ITEM FOR ENVIRONMENTAL COMMISSION AGENDA

NAME & NUMBER OF
PROJECT: 1107 Castle Ridge Road Wastewater Service Extension Request
#5845

REQUEST: Wastewater Service Extension Revision

SUBJECT: 1107 Castle Ridge Road Wastewater Service Extension Request #5845

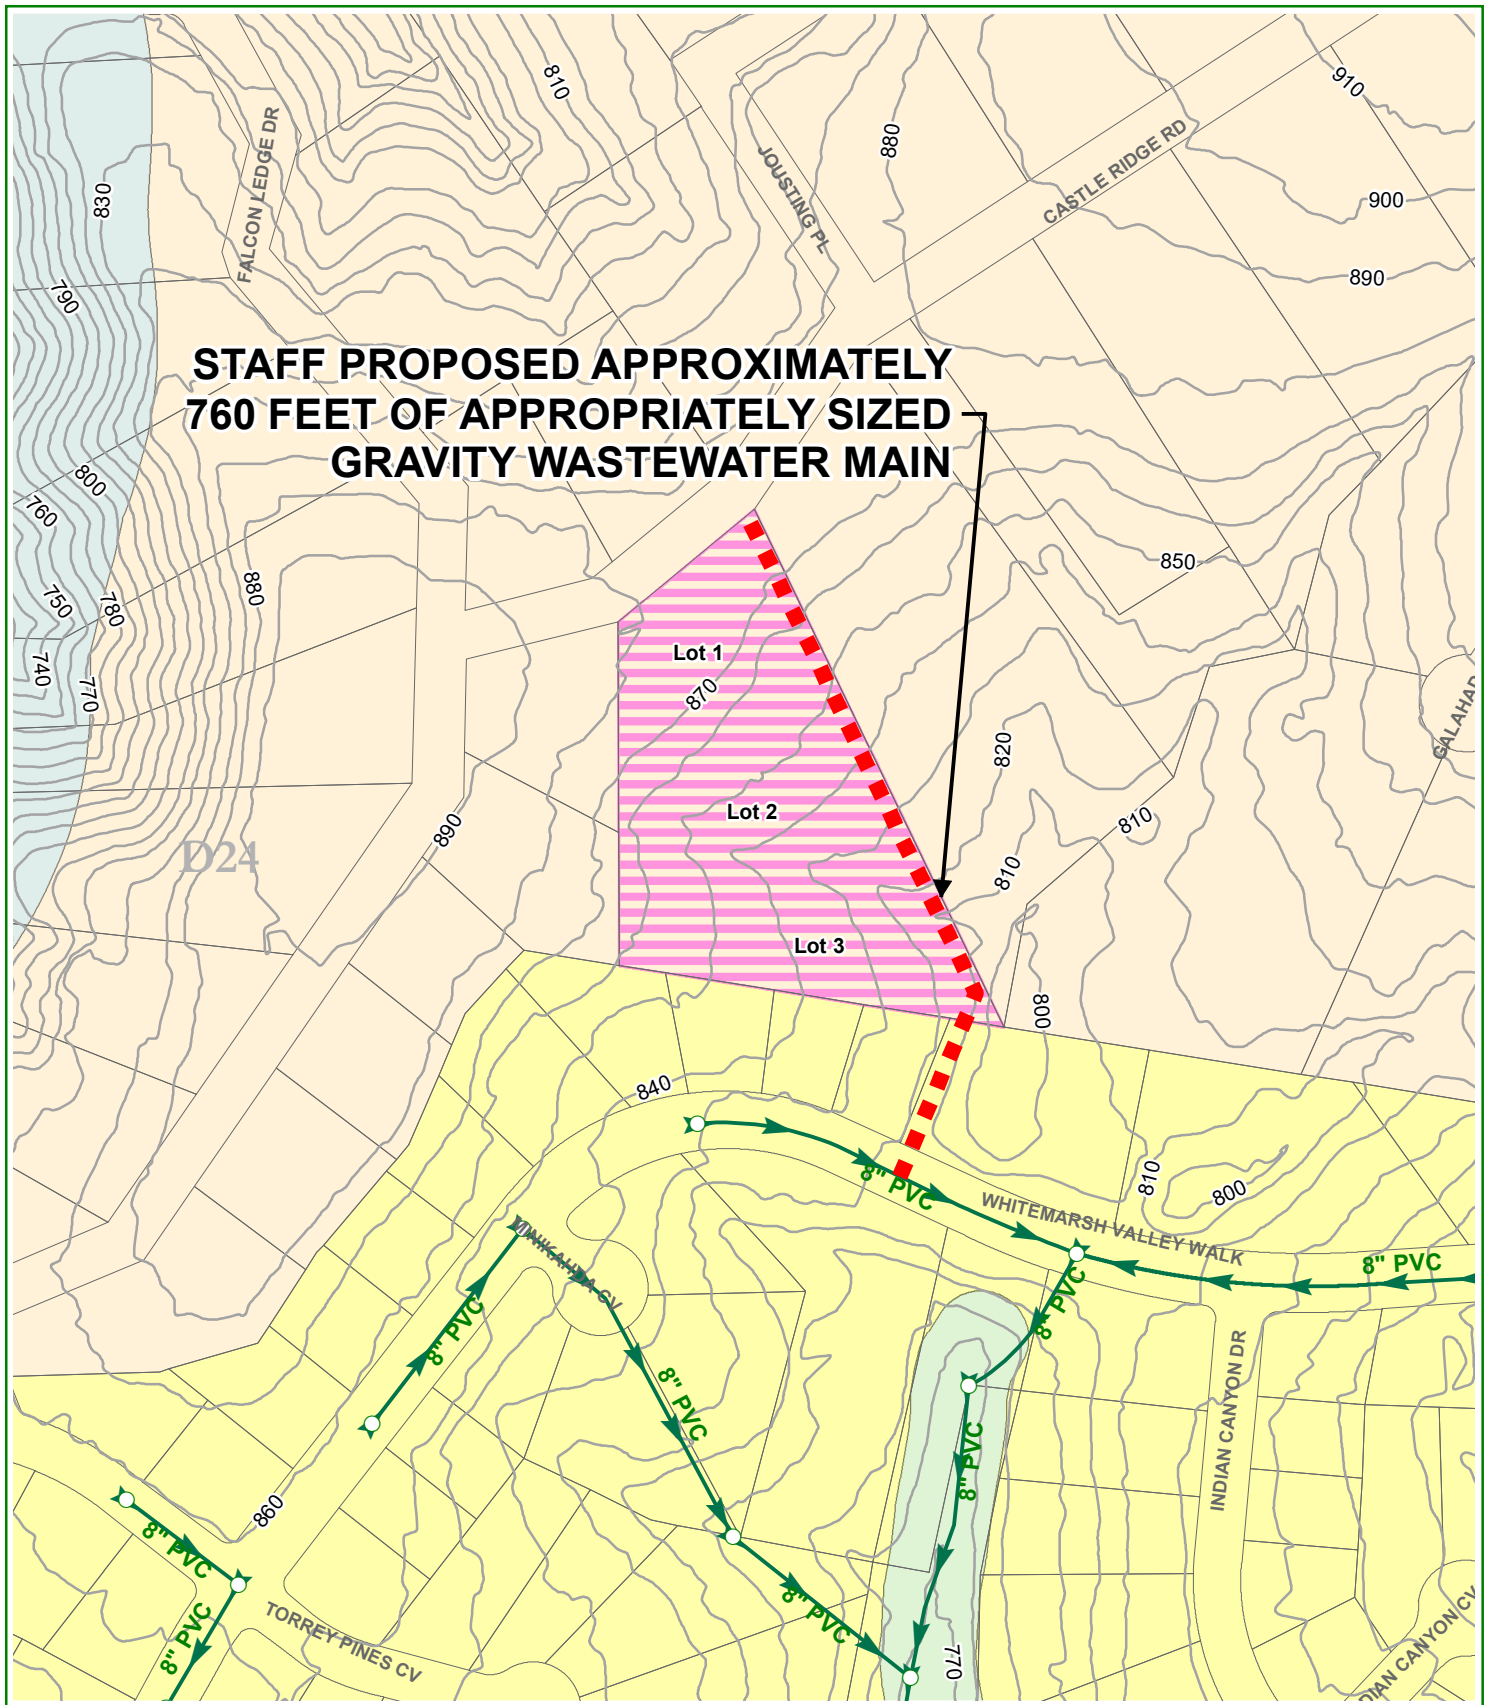
The applicant is proposing to construct 760 feet of appropriately sized gravity wastewater main from the existing 8-inch gravity wastewater main located in Whitemarch Valley Walk and extend north to and through the subject tract to Castle Ridge Road as shown on the attached map.

Zone, the SOS Ordinance limits the total amount of allowable watershed impervious cover to 20% of the net site area and construction on slopes greater than 15% would be limited. Based on available information, a significant portion of the site contains slopes greater than 15%. No critical environmental features were identified in the Environmental Resource Inventory (ERI) and the site is not within the critical water quality zone or water quality transition zone of Barton Creek. The site does not drain to occupied salamander habitat. WPD staff verified the findings of the ERI during a site visit on February 27th, 2024.

The applicant has not submitted a site plan with the City of Austin, but a land use plan was provided with the SER. If the property owner decided to petition for release from the City's ETJ after receiving a wastewater SER for this site, they would be able to develop with fewer environmental protections in place, namely the highly protective SOS impervious cover limits and non-degradation water quality treatment standards, as well as the slope protections found within the WPO.

The Watershed Protection Department does not recommend approval of the wastewater SER #5845 for the following reasons:

- The site contains steep topography with many areas of slopes greater than 15% and is therefore sensitive to impacts of development,
- The original subdivision was approved prior to the adoption of the Save Our Springs Ordinance and facilitating additional density and impervious cover in this neighborhood beyond what exists currently could lead to an overall increase in non-compliance with the SOS ordinance over time,
- WPD supports development that complies with the City of Austin's environmental regulations and currently there are no assurances that the site will continue to remain within the City of Austin's ETJ in the future. If the site were to request removal from Austin's ETJ, it would no longer be subject to Austin's environmental regulations, including the SOS Ordinance.
